SERVICE BULLETIN

Original Issue Date: 11/04
 Model: 8-32EOZD and 6.5-27EFOZD
 Market: Marine
 Subject: Single-Phase Reconnection Decal

Figure 1 Reconnection Decal Location

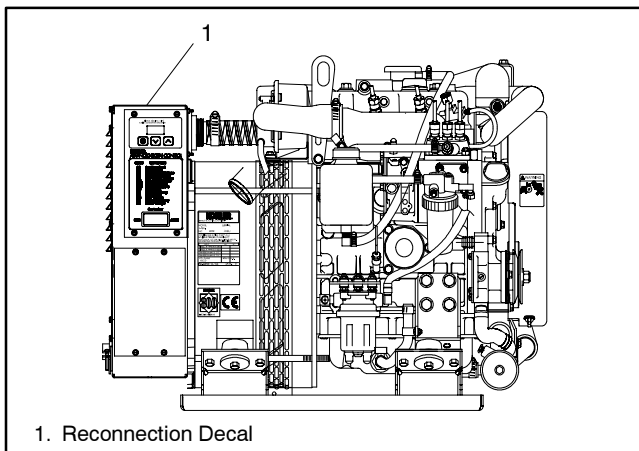
Check 8-32EOZD and 6.5-27EFOZD marine models located in your stock. If any of these units include the incorrect decal (229831) shown in Figure 2, cover the decal with the correct decal (GM35838). The reconnection decal may be located either on the top of the junction box or on the inside of the junction box. See Figure 1 for location.

Figure 3 Correct Reconnection Decal (GM35838) for EOZD/EFOZD Units with ADC 2100

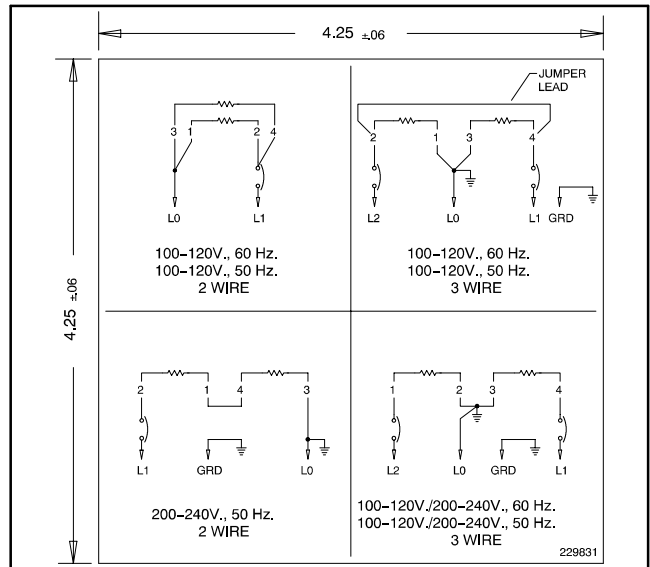
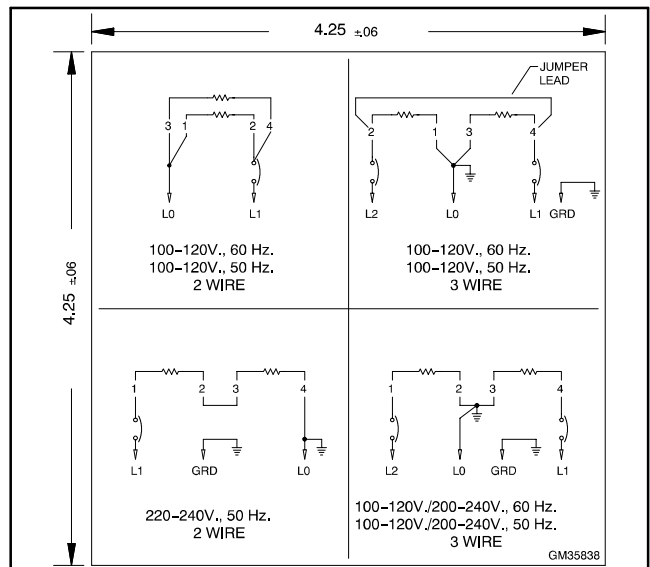
Some early model EOZD/EFOZD marine generator sets were shipped from the factory with an incorrect reconnection decal. Single phase marine generator sets equipped with an ADC 2100 should follow the reconnection details depicted in decal number GM35838 (see Figure 3).

Note: Refer to Figure 2 and Figure 3 and notice the change for 220-240 volt, 50 Hz, 2-wire reconnection.
